## Determination 2012/018

### The code-compliance of a deck added to a house at 30A Hertford Street, Blockhouse Bay, Auckland

2.5.1 The deck considered in this determination is to the southwest internal corner of the altered upper floor, above the new main entry as shown in Figure 1:

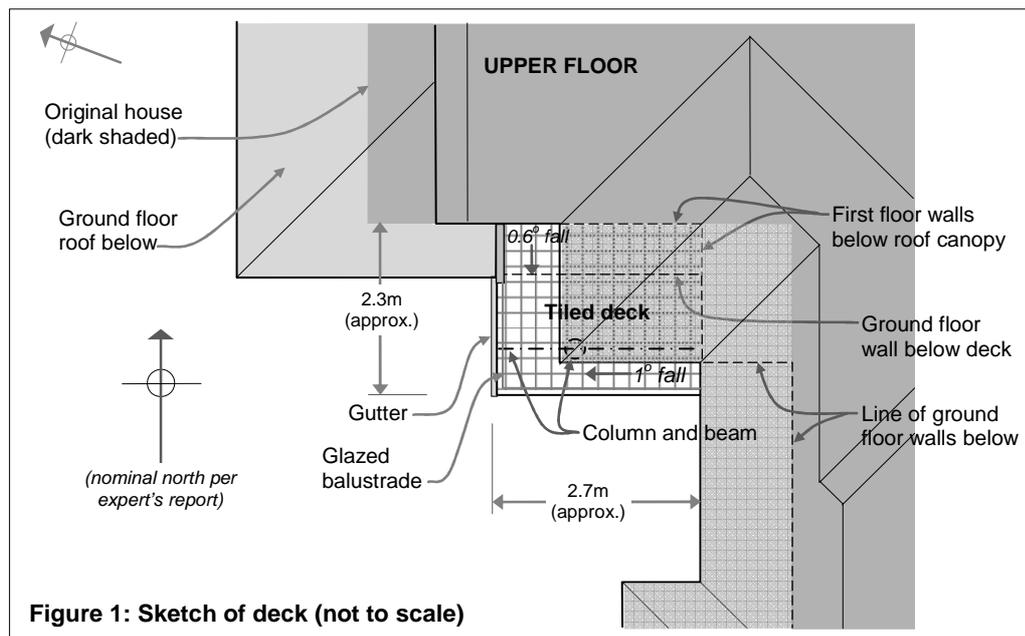
2.5.2 A strip of about 700mm of the 6m<sup>2</sup> deck sits above the ground floor living area. The remaining deck floor is supported by a column and boxed beam, with a small cantilever along the south. The column extends to support a roof projection, which covers about half of the deck area. Glazed balustrade posts are side-fixed to the south edge, with a west post side-fixed to a part-height clad wing wall.

2.5.3 The deck floor has tiles over a membrane on a plywood substrate, which slopes at 1° towards a gutter at the western edge, with a 0.6° cross slope. The applicator's producer statement does not specify the thickness or brand of the particular membrane, stating only that it is 'EPDM'<sup>5</sup>.

Deck membrane does not have 1° fall, has cladding hard down on membrane, has balustrade fixed through the membrane...

1<sup>st</sup> floor deck falls 0.4°. Needs determination.

Note: Drawing S6 first floor plan shows deck falls required as 2°.

- No new staircase was built, with the original staircase retained.
  - The deck plan shape was constructed as a rectangle rather than curved.
  - The deck slope is about 1°, in lieu of the 2° shown in the drawings.

- The deck slopes to an external gutter instead of a deck outlet.
- 5.3 The expert described the construction of the deck, noting that
- about half of the deck is beneath a projecting roof

- 5.6 Commenting specifically on the deck, the expert noted that:
- the weatherboards to the east wall and the west wing wall butt against the deck tiles, with grout applied to the junctions, preventing drainage from the wall cavity and allowing moisture to wick into the boards

- the low metal capping over the curb at the south edge allows moisture to track over the underlying membrane, with the membrane to fascia junction unable to be confirmed.

6.3.3 However, on the evidence available to me, I am not satisfied that the deck tiling has been installed to the membrane manufacturer's instructions in accordance with published good tiling practice. Taking account of the expert's report, I conclude that investigation and/or remedial work is necessary in respect of:

- confirmation by the tile installer of the adhesive used for the deck tiles
- the lack of clearances between tiles and weatherboards
- investigation of the adequacy of the as-built detail at the membrane to fascia junction under the south capping.
